CONSTRUCT T-HANGAR & T-HANGAR TAXILANES
FOR THE WARSAW MUNICIPAL AIRPORT
CONTRACT NO. 17-023A-1
ADDENDUM NO. 5

May 11, 2018

Addendum No. 5 consists of the following clarifications, changes, additions, etc.

**CONSTRUCT T-HANGAR & T-HANGAR TAXILANES
BASE BID PAVEMENT LAYOUT
LAYOUT AND ELEVATION PLAN**

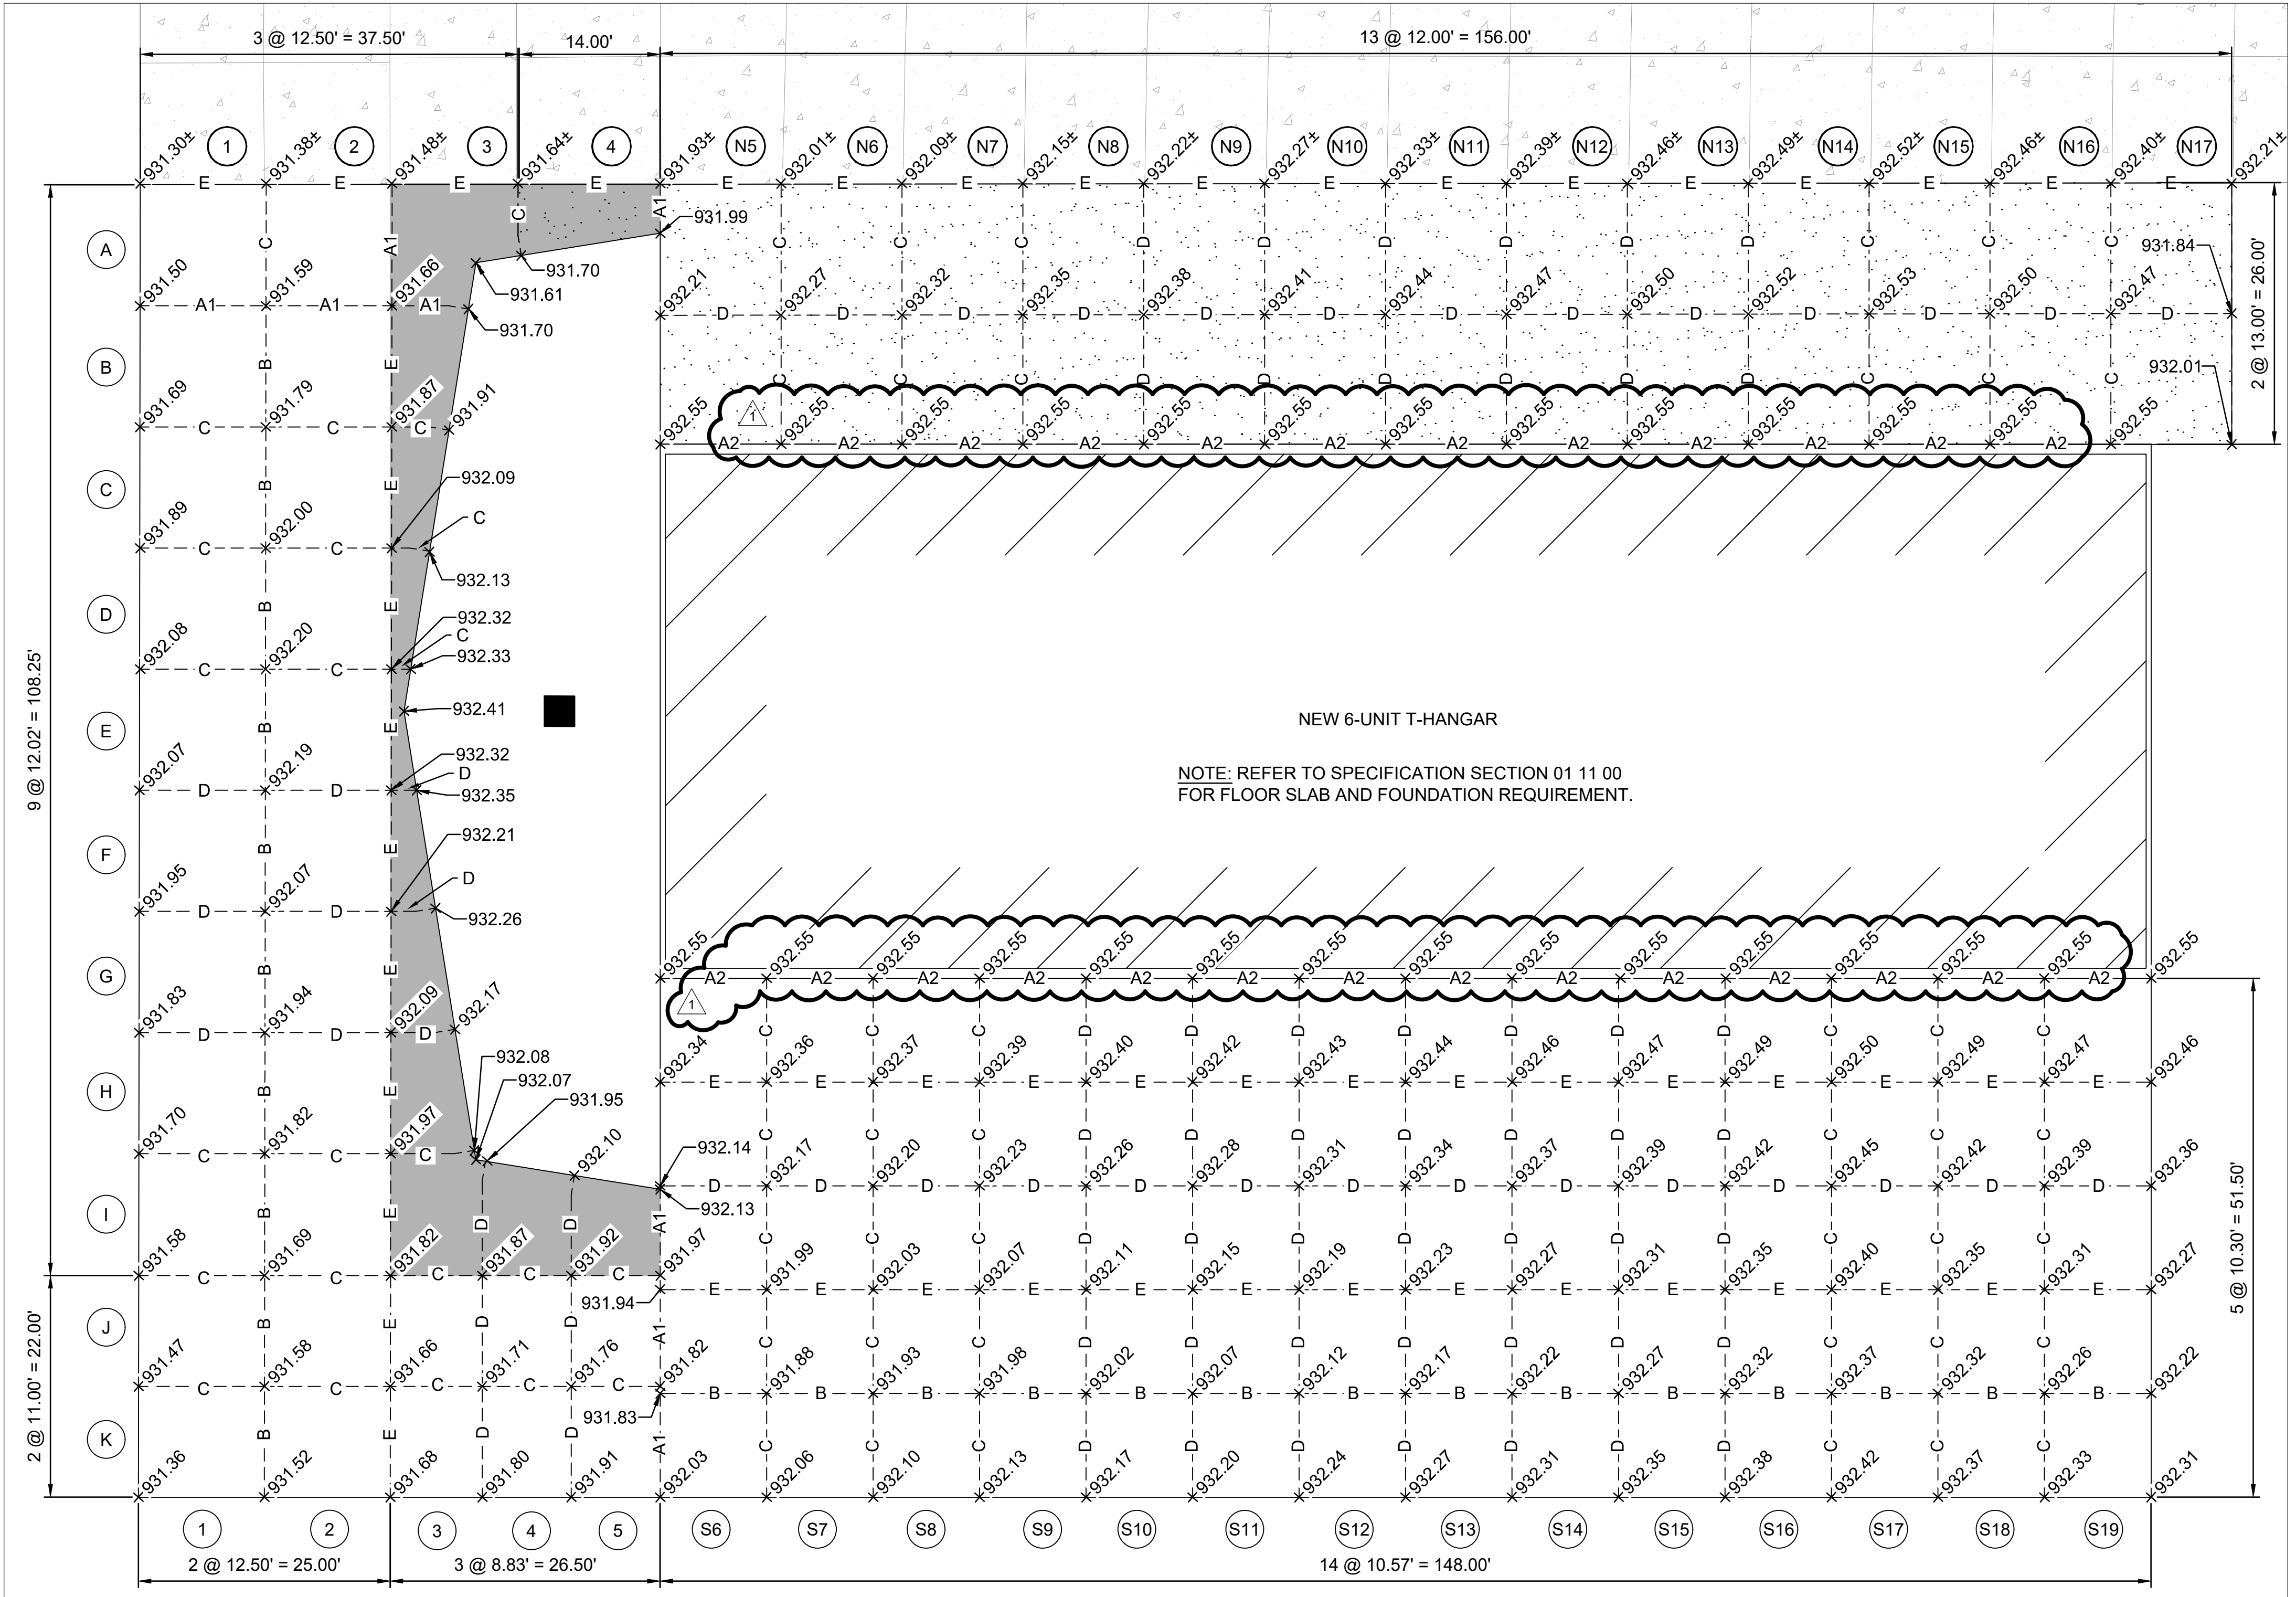
Replace Sheet C-301 with the attached revised Sheet C-301.

**CONSTRUCT T-HANGAR & T-HANGAR TAXILANES
BID ALTERNATE PAVEMENT LAYOUT
AND ELEVATION PLAN**

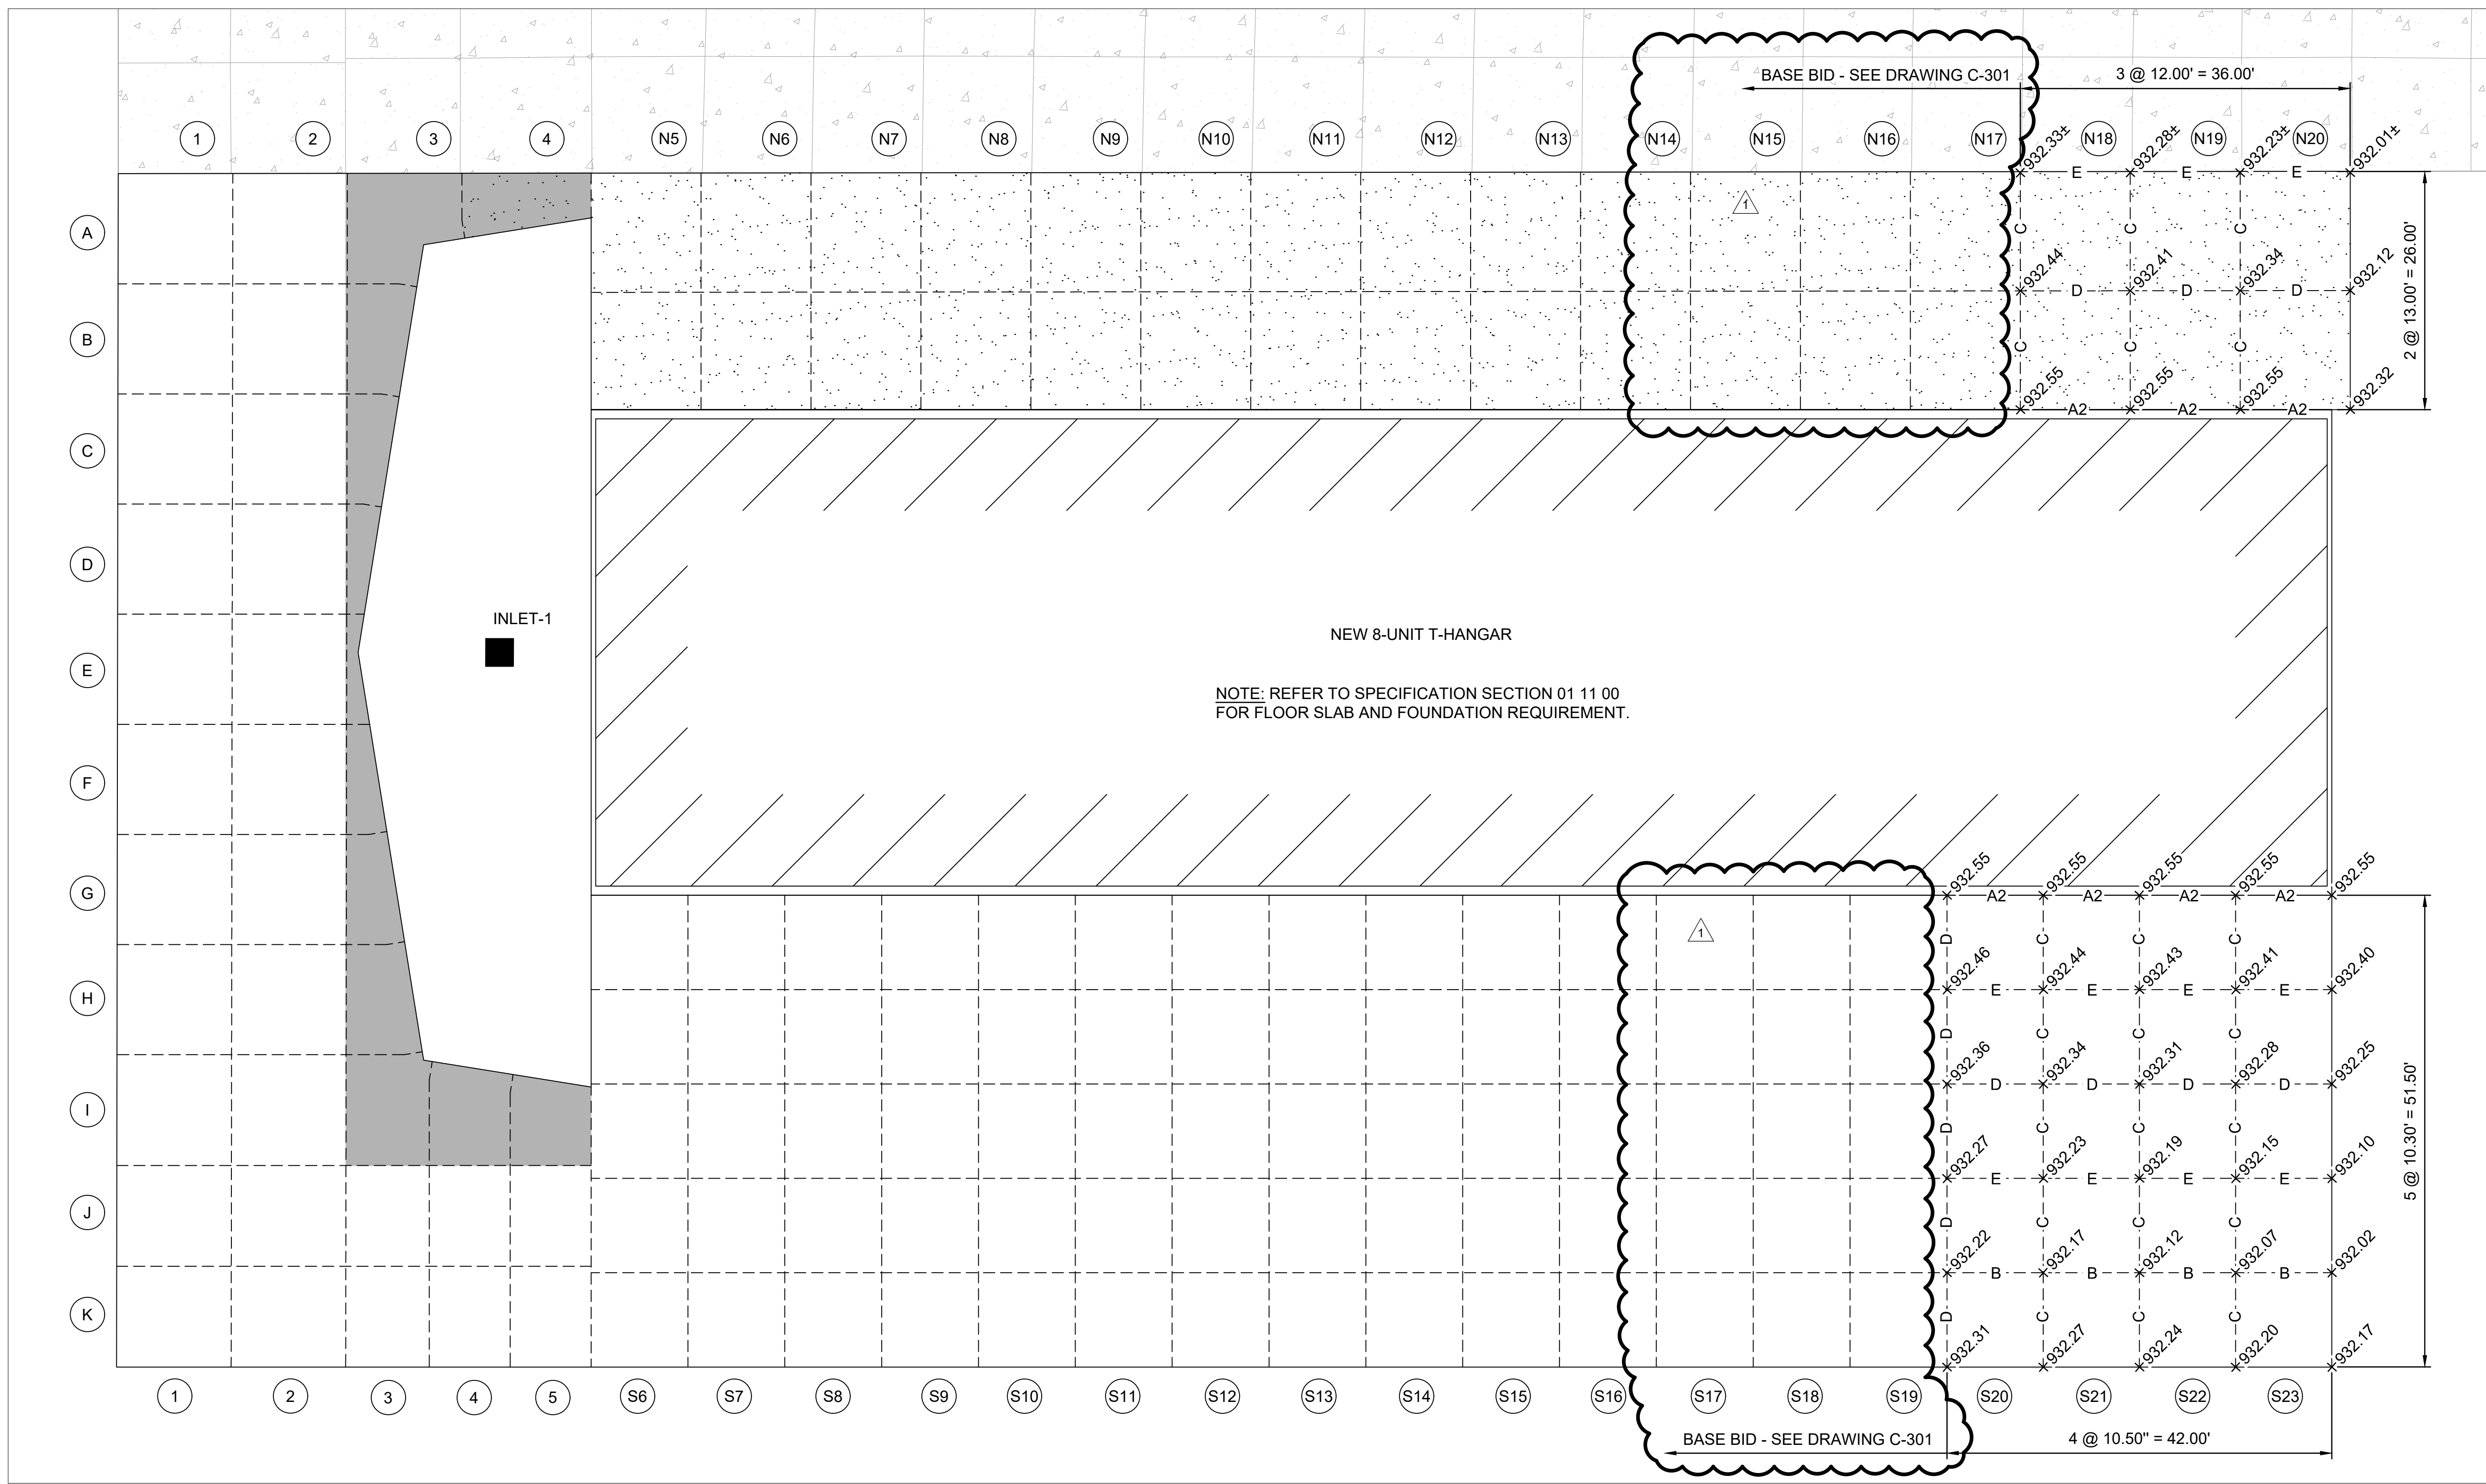
Replace Sheet C-302 with the attached revised Sheet C-302.
